DEVIATION REQUEST AND DECISION FORM

Project Name : CLOVERLEAF SUBDIVISION
 Schedule No.(s) : 7124202236, 7124202237, 7123102041, 7123102044
 Legal Description : SEE ATTACHED – Exhibit C

WHITE CLOVER DRIVE AND LEGGINS WAY INTERSECTION SIGHT DISTANCE

WHITE CLOVER DRIVE AND
 LEGGINS WAY INTERSECTION
 SIGHT DISTANCE
 CLOVERLEAF
 JOB NO. 2000-5158.01
 11/06/2020
 SHEET 1 OF 1

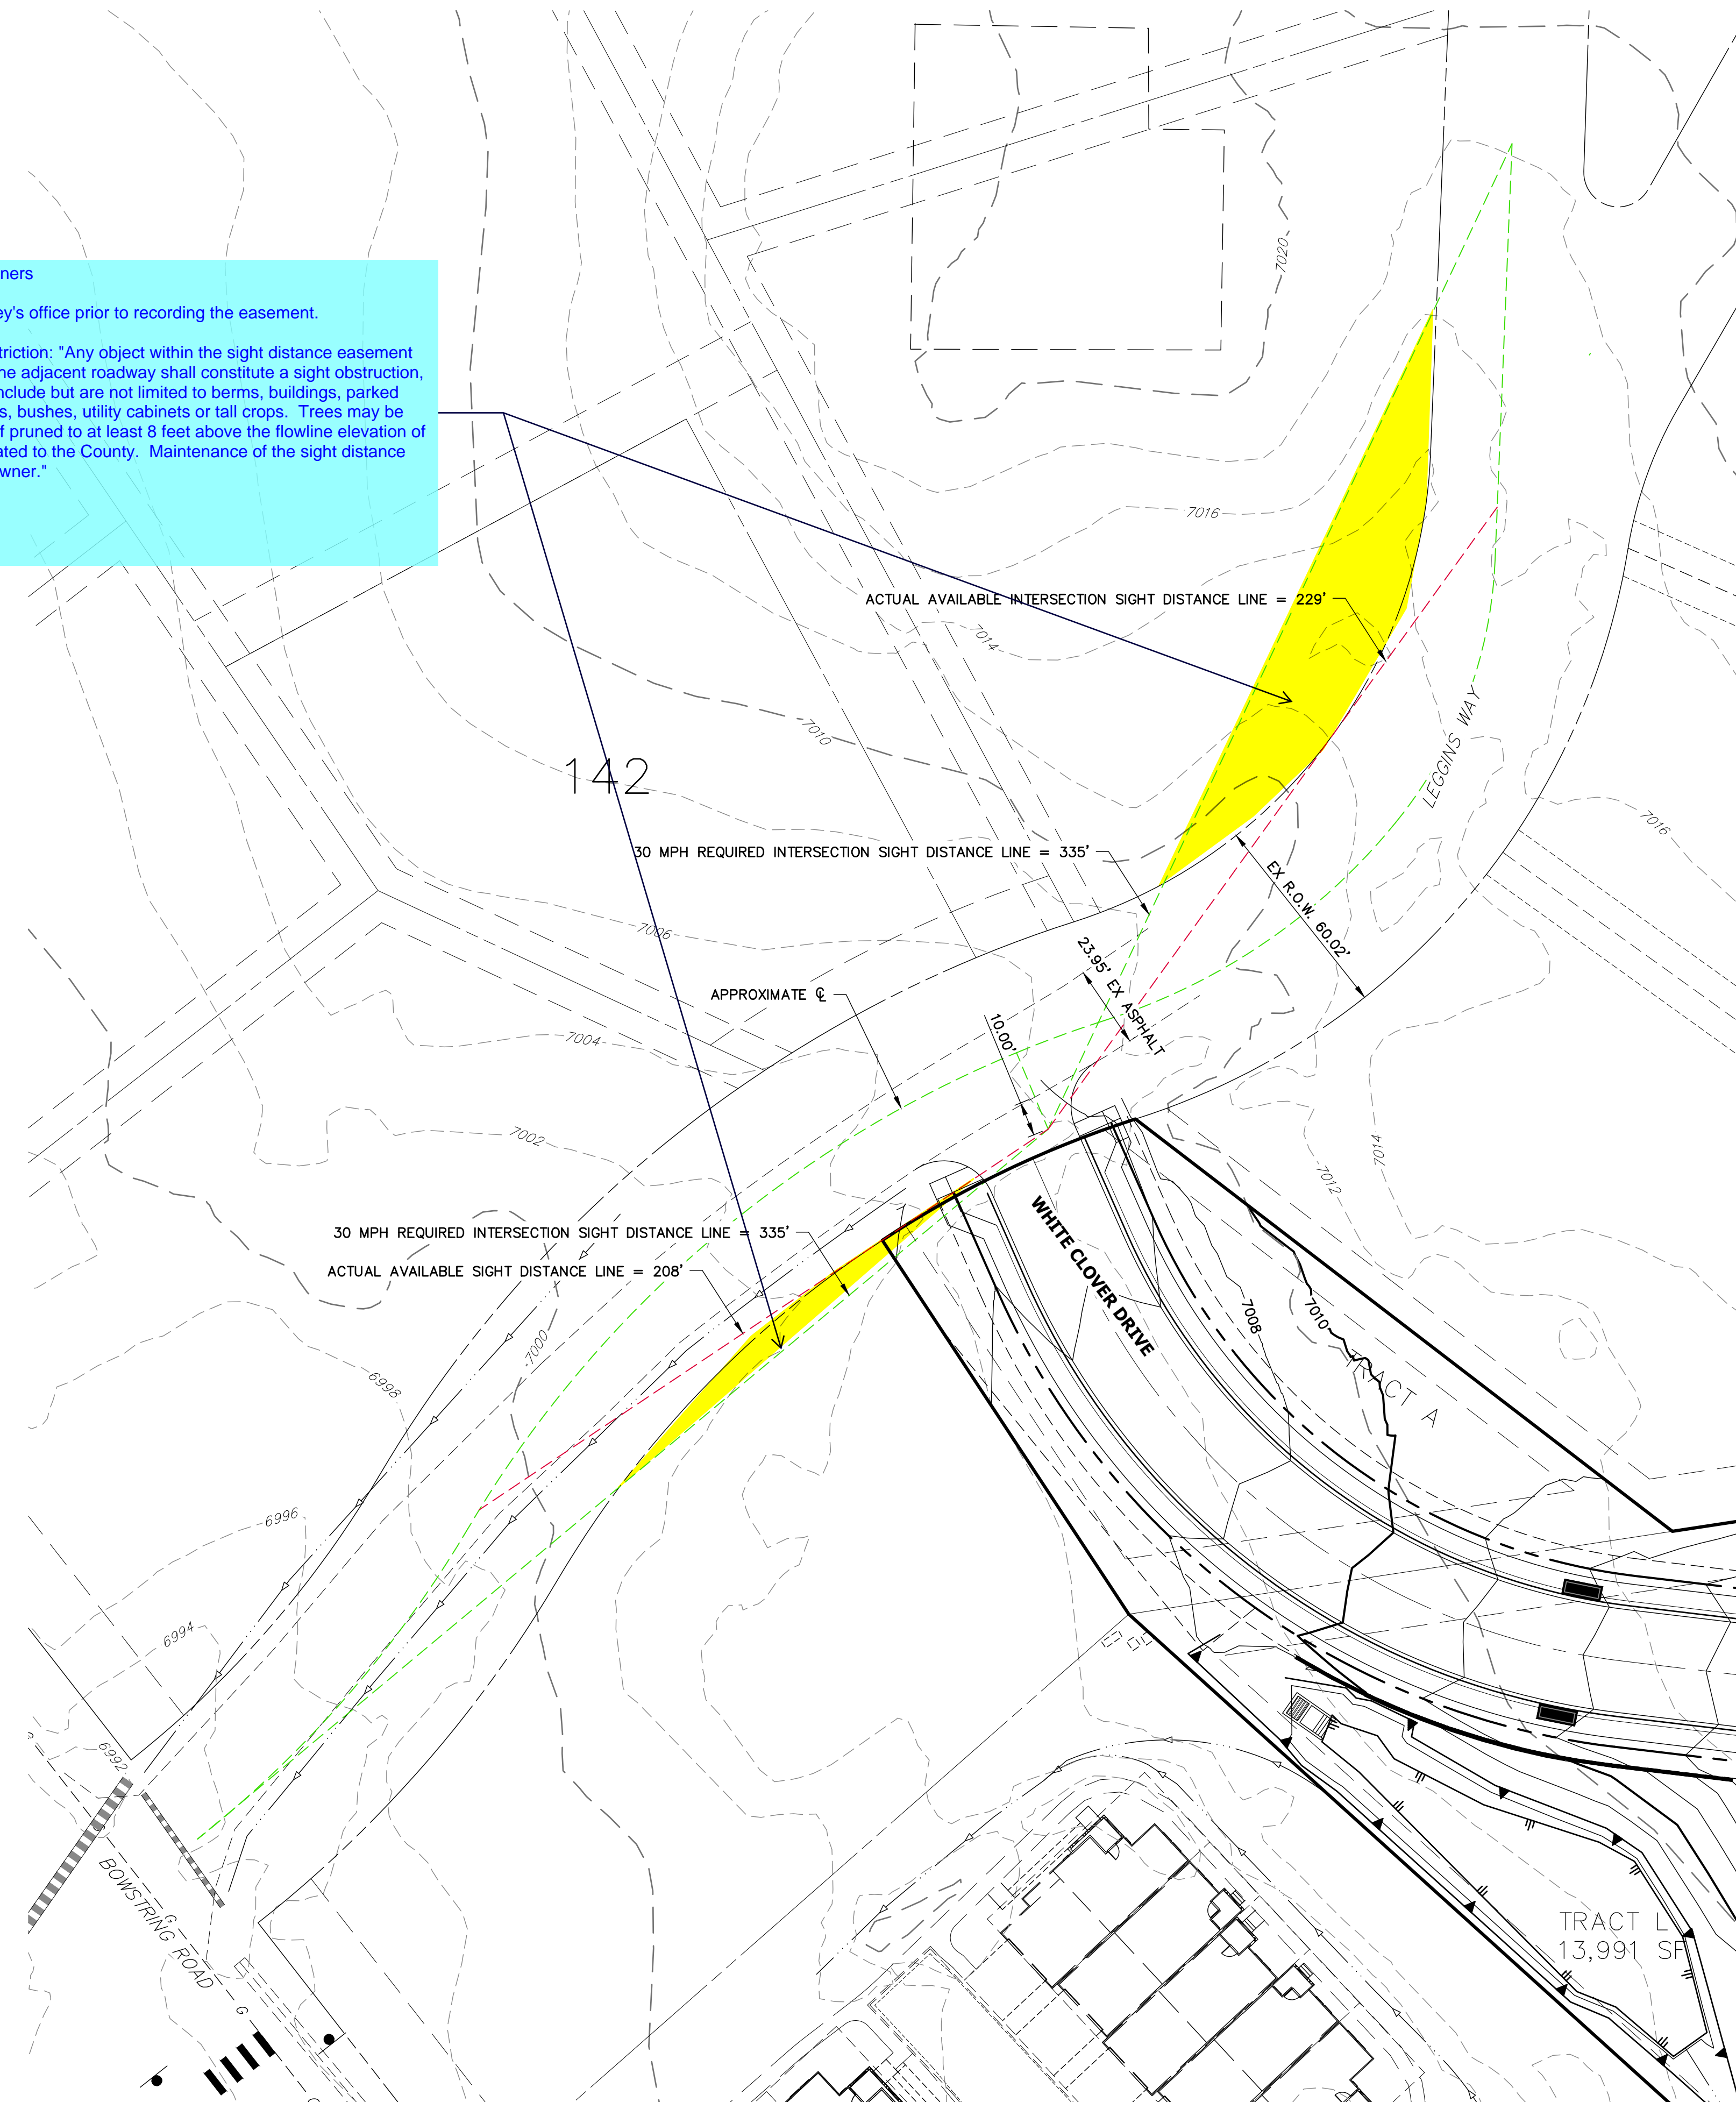
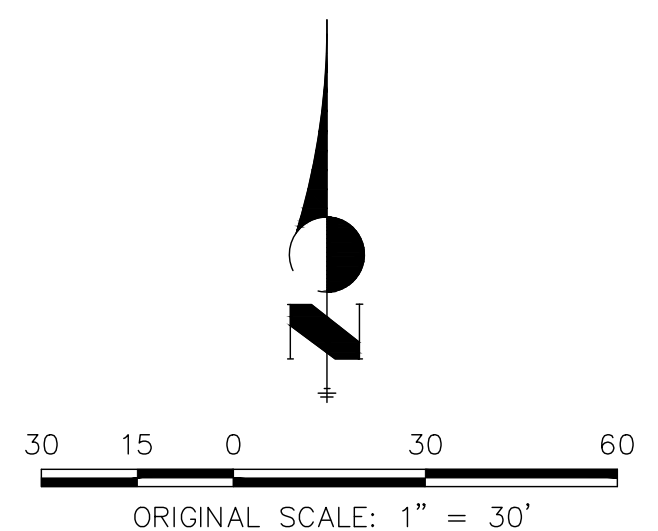
Obtain sight distance easement from the property owners
 Submit the easement for review by the County Attorney's office prior to recording the easement.

Sight distance easement must have the following restriction: "Any object within the sight distance easement more than 30 inches above the flowline elevation of the adjacent roadway shall constitute a sight obstruction, and shall be removed or lowered. The objects may include but are not limited to berms, buildings, parked vehicles on private property, cut slopes, hedges, trees, bushes, utility cabinets or tall crops. Trees may be permitted at the discretion of the ECM Administrator if pruned to at least 8 feet above the flowline elevation of the adjacent roadway. The easement shall be dedicated to the County. Maintenance of the sight distance easement shall be the responsibility of the property owner."

Show the proposed signage type and location.
